**I. Independent Review of Selected Sections of the
2009 West Valley Decommissioning Final
Environmental Impact Statement**

for the
New York State Energy Research and Development Authority
November 20, 2009

**II. Independent Review of the Draft Environmental
Impact Statement for Decommissioning and/or
Long-Term Stewardship at the West Valley
Demonstration Project and Western New York
Nuclear Service Center**

for the
New York State Energy Research and Development Authority
September 3, 2008

Figure 3 (Figure 2-10 in Sitewide report) WMA 2 Cap and Barrier Wall

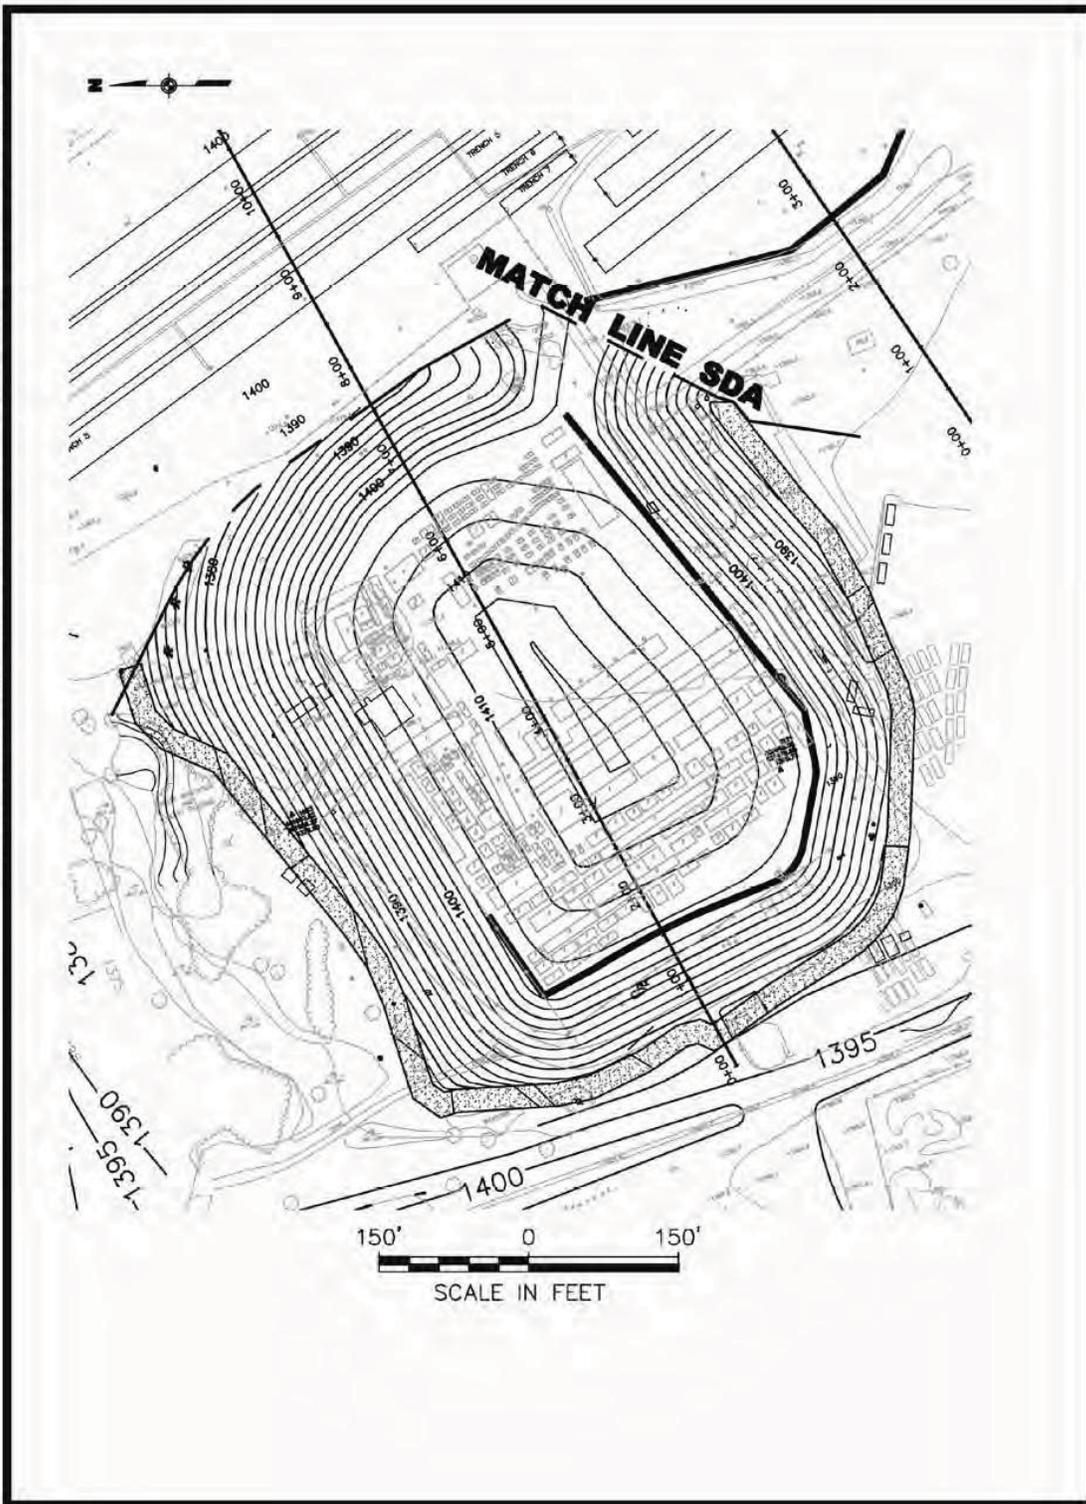
The plan for in-place closure of WMA 2 is described in Section 2.2 of the Sitewide Close-In-Place report and is illustrated in Figure 3, taken from that report. The plan is to cement the sediments in lagoons 1, 2, and 3, and to install clean fill in lagoons 4 and 5. A soil-bentonite barrier wall would surround lagoon 1 “to divert groundwater around the portion of the lagoon that is below the groundwater table.” Piping would be grouted in place.

Figure 4 (Figure 2-27 from Sitewide report) WMA 7 Cap and Barrier Wall

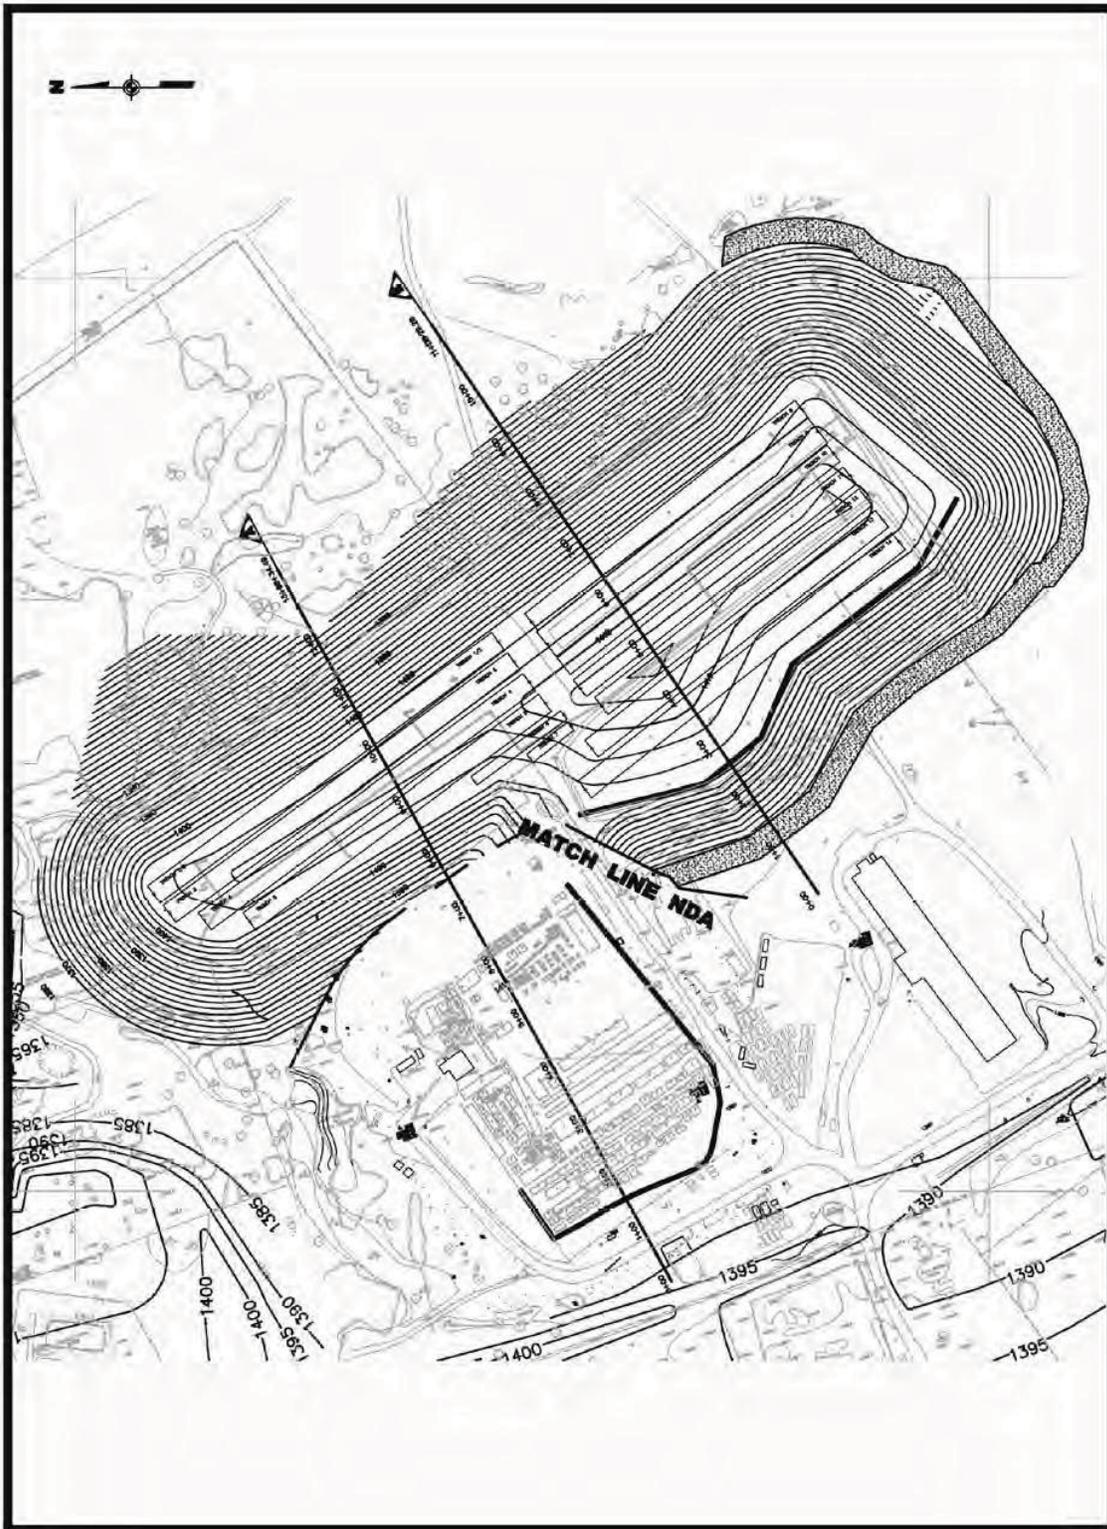
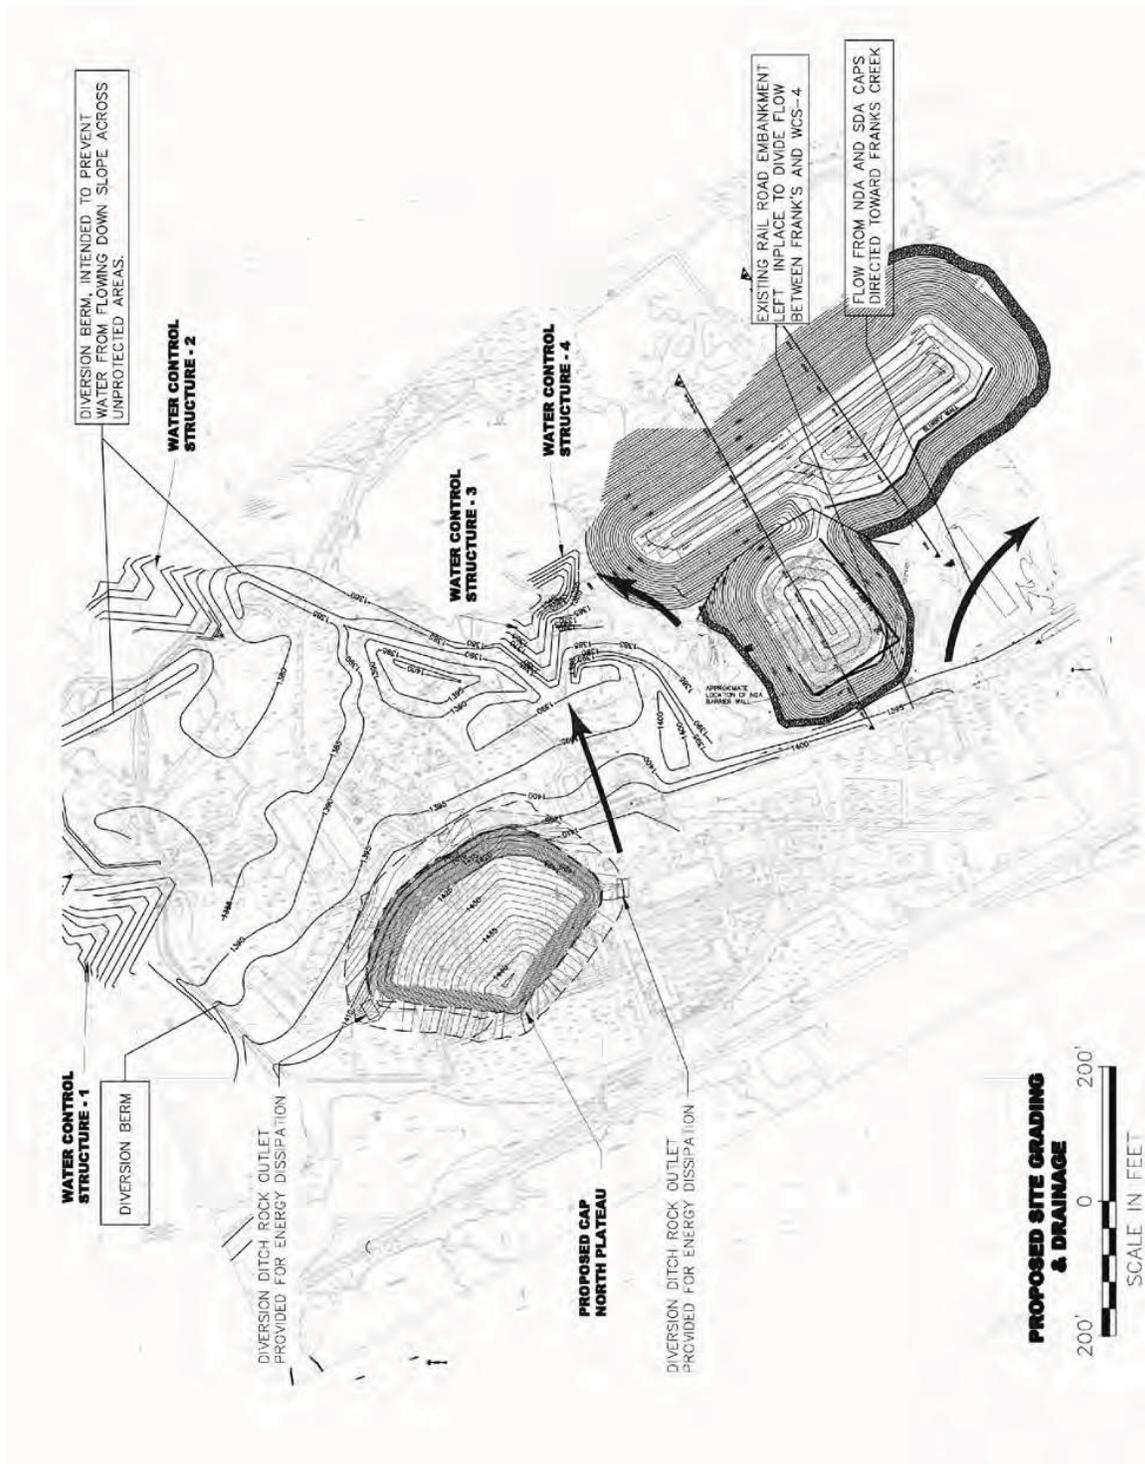
The NDA and SDA are described together because the approach to these areas is similar. The plan is for the trenches and disposal holes in the NDA and SDA trenches to be grouted, covered with geomembrane caps, and surrounded by slurry walls. Figures 4 and 5 illustrate the closure plan.

Figure 3-5. Environmental Airborne Releases by Implementation Year

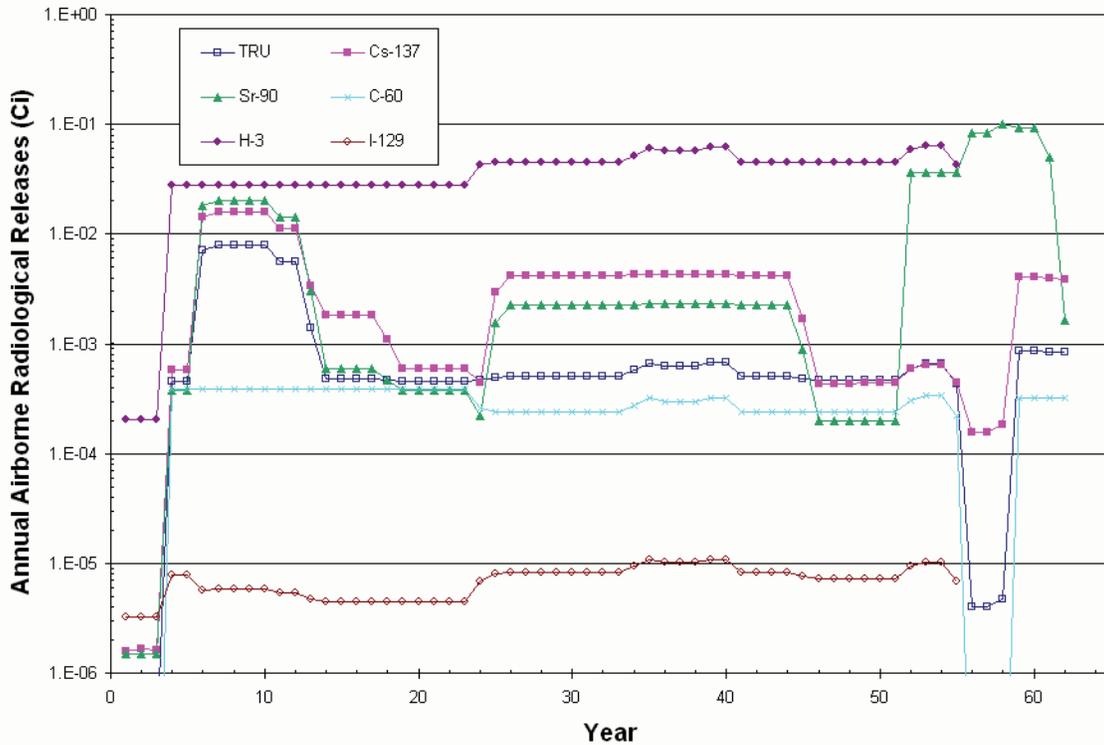
The second example deals with double containment for most of the NDA and SDA.

The wisdom of double containment for complete sites is questionable since the atmospheric releases are only 0.1 curies per year of tritium and barely 0.01 of other nuclides are being released to the atmosphere. After 50 years Sr-90 spikes (no explanation is given for that figure except that it involves the removal of the North Plateau Groundwater Plume but does not say what preventive measures such as wetting the soils and noting that strontium does not volatilize) but is still less than 0.1 curies per year. (Figure 3-5 of the STRA.)

Figure 2-28. Conceptual NDA Environmental Enclosure

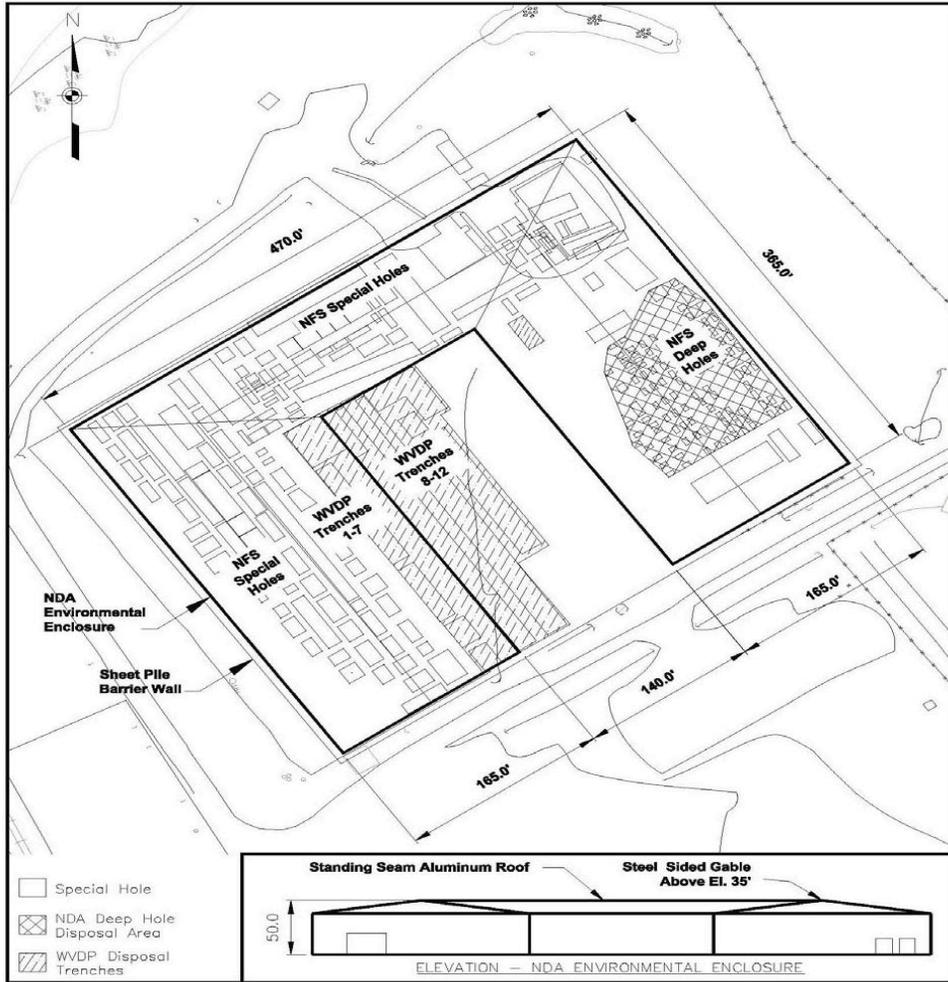
The exact dimensions of the Modular Shielded Environmental Enclosure are unclear as the Perspective View has no dimensions and the Wall and Panel Sections do not show all of the measurements. It is surprising that these structures will not be reused at the SDA but will be demolished at the conclusion of activities.
